Airworthiness Directive Schedule

Embraer EMB-820C, S/N 820127

25 March 2010

Figure 1: Borecope Probe Access Points

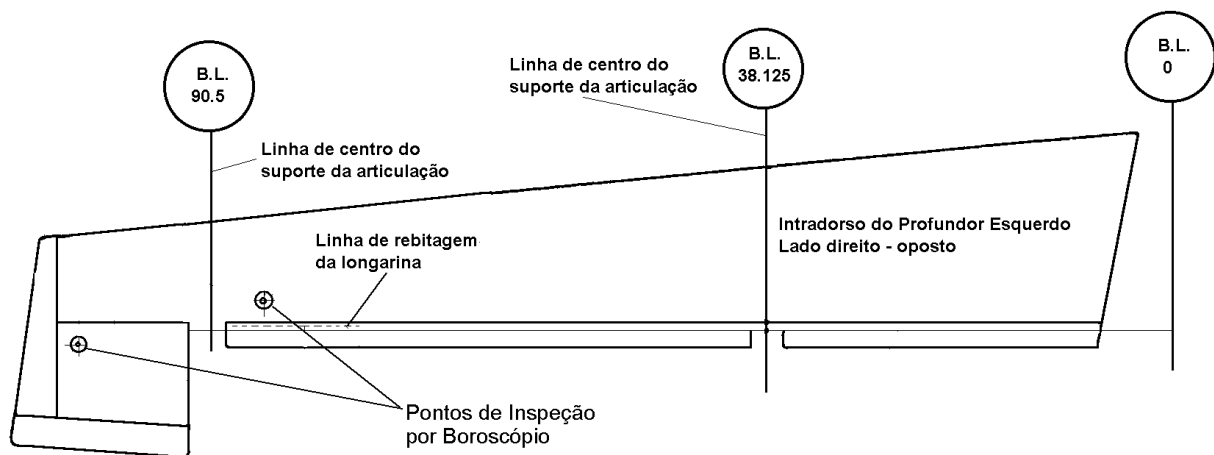
Requirement: To prevent failure of the elevator spar due to possible insufficient rivet edge margins, accomplish the following:

With the aid of a boroscope inspect the elevator spar for defects and rivet spacing through the access points per figure 1.

Figure 2: Inspection Area

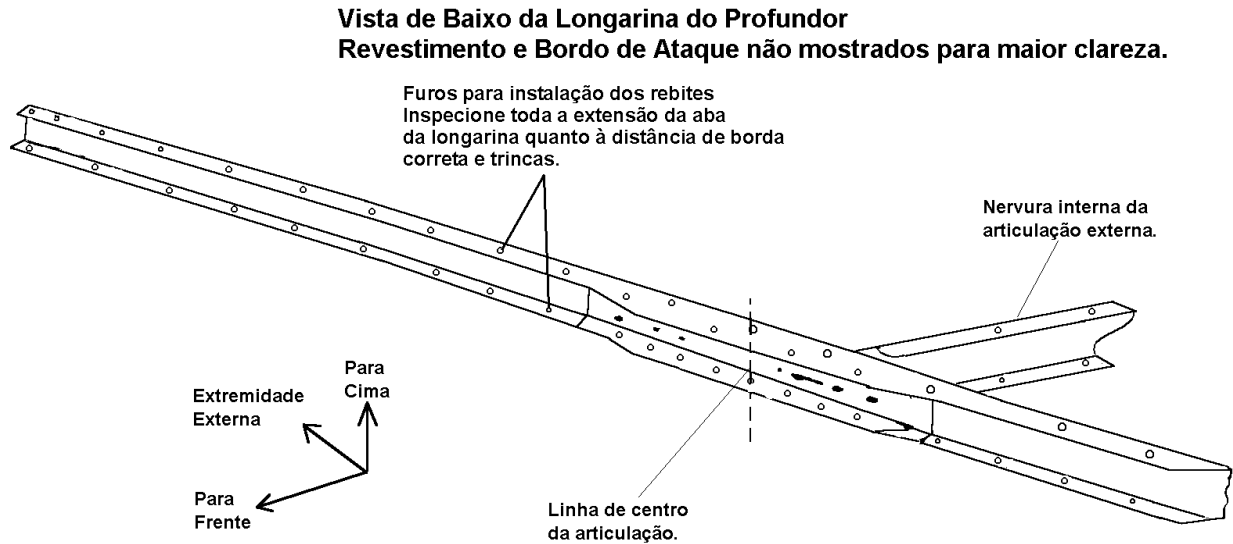
Inspect the elevator spar per figure 2 for any defects and determine that the rivet edge margins are within the limits specified by the aircraft manufacturer.

If no defects are found and the rivet edge distances are found to be within the limits specified by the aircraft manufacturer, no further AD action is required.

If any cracks or defects are found contact the aircraft manufacturer for further advice and accomplish a manufacturer approved repair, or replace the elevators before further flight.

If the rivet edge margins are not within the limits specified by the aircraft manufacturer, inspect thereafter per the requirements of this AD at intervals not to exceed 100 hours TIS.

FIGURA 1 - SUBSTITUIÇÃO DOS SUPORTES DE ARTICULAÇÃO DO COMPENSADOR DO PROFUNDOR

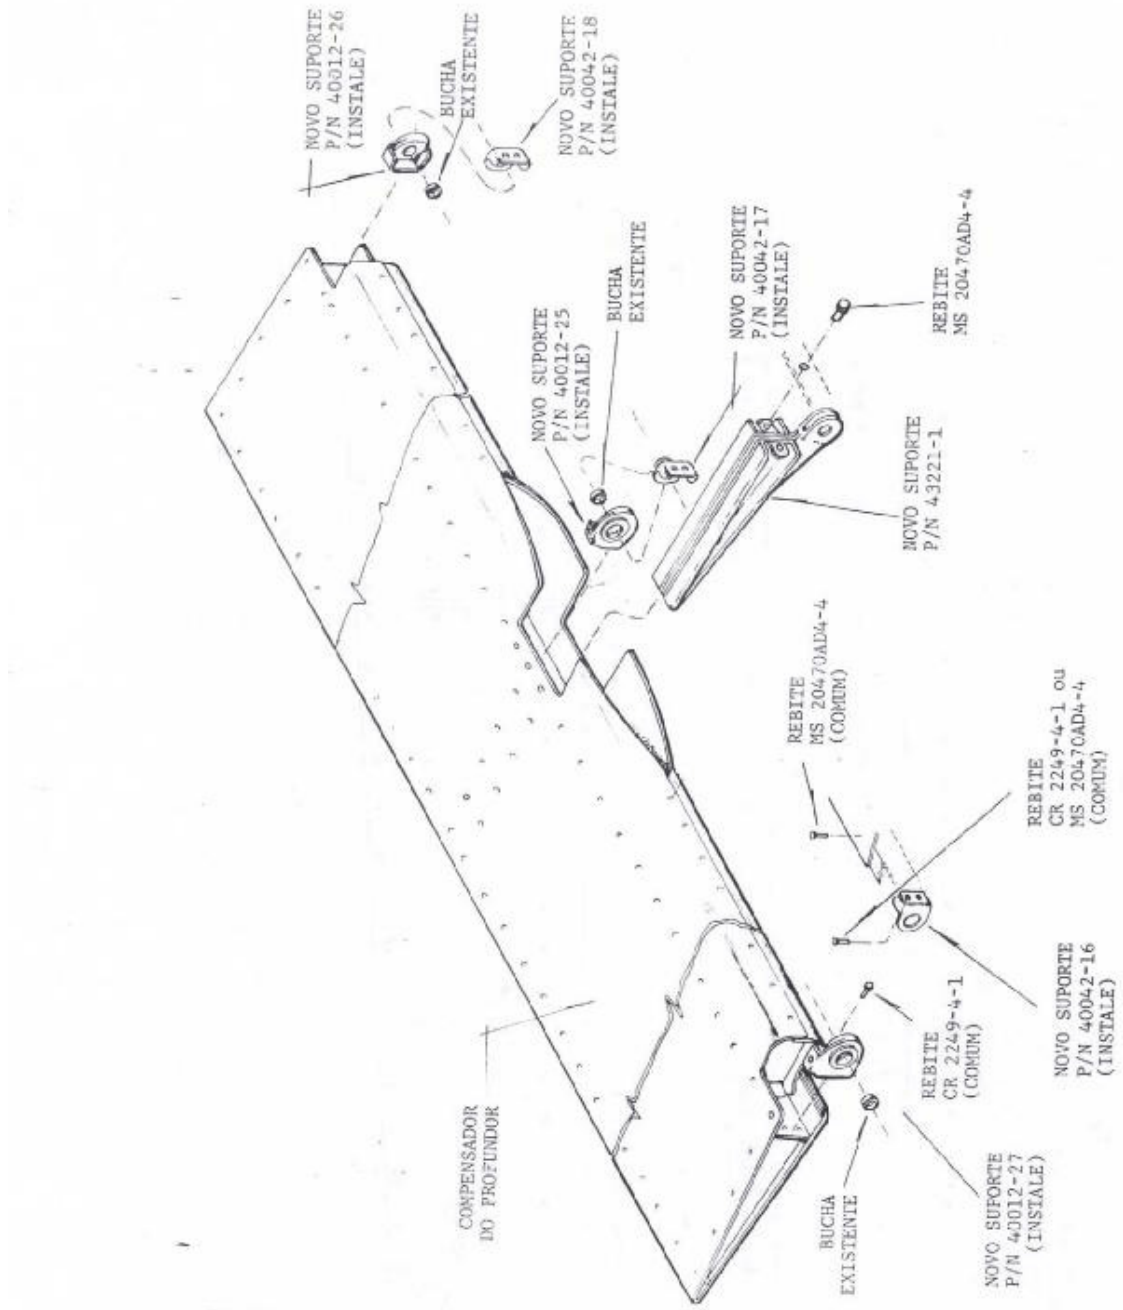
Requirement: To prevent failure of the elevator trim tab brackets, accomplish the following:
 Remove the elevator trim tab per the instructions in the aircraft maintenance manual and take care not to lose the trim tab pivot bushes. Remove the existing brackets P/N 40042-08, 40042-09 and 40042-10 and discard them. Install new steel brackets P/N 40042-16, 40042-17 and 40042-18 using the existing screws. Refer to figure 1 for the positions of the hinge brackets of the elevator trim tab.

Remove supports P/N 40012-12, 40012-13 and 40012-22 and install new steel supports P/N 40012-25, 40012-26 and 40012-27 on the elevator trim tab.

Figure 2: Position of the rivets.

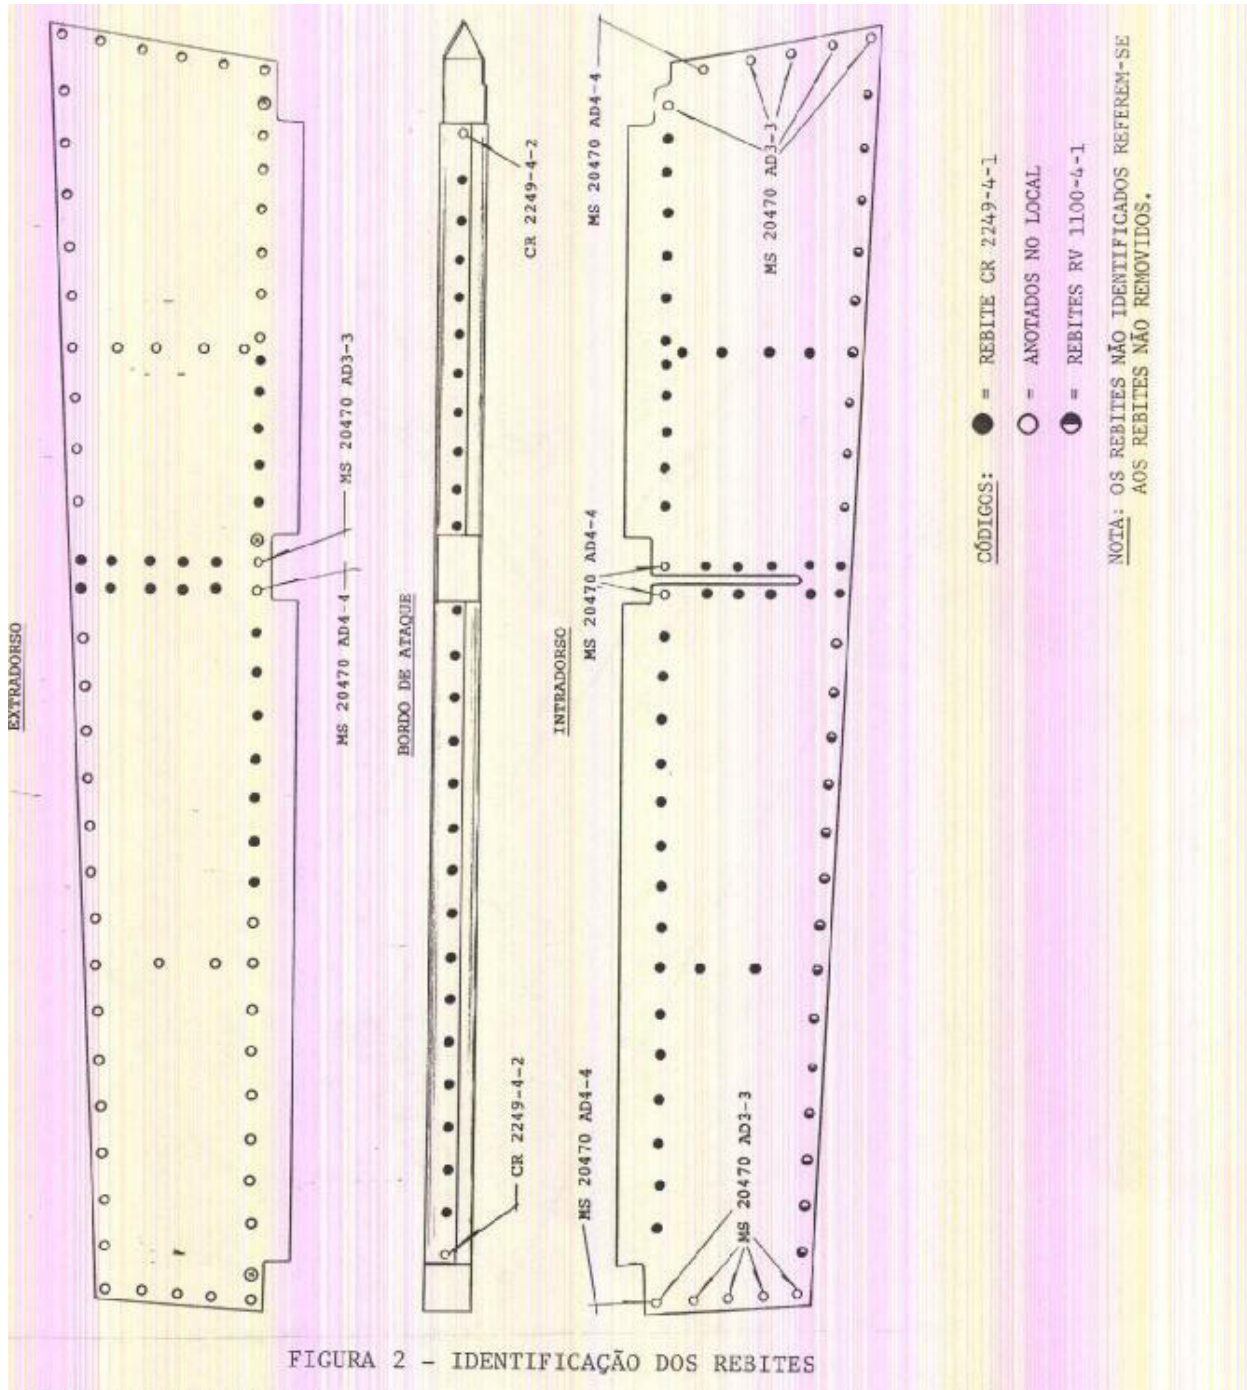
Remove trim control rod bracket P/N 43221 and replace with bracket P/N 43221-1. Touch up any exposed metal parts with paint as required. Accomplish these corrective actions per manufacturer approved procedures. Refer to figure 2 for the position of the rivets which hold the new elevator trim brackets and trim control rod bracket P/N 43221-1 in position.

Figure 1: Aileron Balance Cable End Fitting and Bellcrank Inspection.

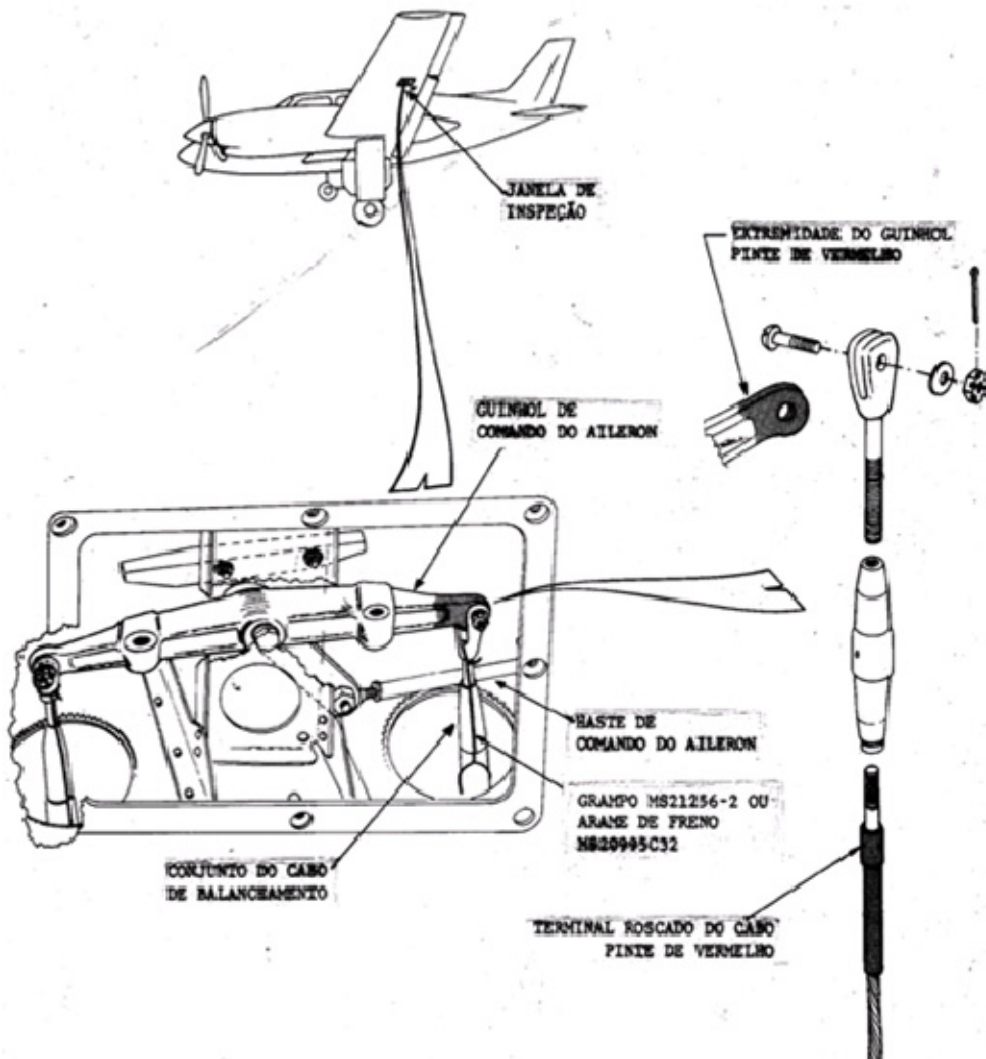
Clean the aileron balance cable end fitting and the attach end of the bellcrank in both wings of the aircraft and determine if both are marked with red paint per figure 1 of this AD. No further action is required if both fittings are marked with red paint in both wings.

If no red paint markings are found on the aileron balance cable end fitting or the bellcrank end, move the aileron control system through the full travel and inspect for any defects. Determine whether the bellcranks are fitted in the correct orientation and determine that the aileron balance cable end fittings are fitted to the bellcrank in the correct orientation. Replace any defective parts as required before further flight. Ensure the aileron bellcranks and the aileron balance cable end fittings are marked with red paint and fitted correctly per the manufacturer instructions.
